Conservation Team Advice

Date: 9th February 2026
Application Ref: DOC/2025/0098
Site Address: London Mill, Ashbourne Road, Leek
Proposal: Discharge of Conditions 10, 11 & 12 in relation to application SMD/2023/0191

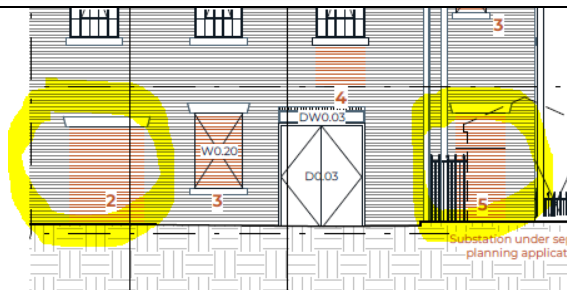
- Timber External Door Schedule (dwg no. 25 031 – INC – DR 1263 Rev B)
- Aluminium External Door Schedule (dwg no. 25 031 – INC – DR 1262 Rev A)
- Door Type 1 is the main entrance door facing Ashbourne Road. The proposed details on dwg no. 25 031 – INC – DR 1263 Rev B show a raised and fielded door with two panels and a horizontal

panel across the top. It would be suggested that the design of the replacement door replicates the historic detailing of the 3 panelled door, see historic photo below (the detailing here appears to be bolection moulding):
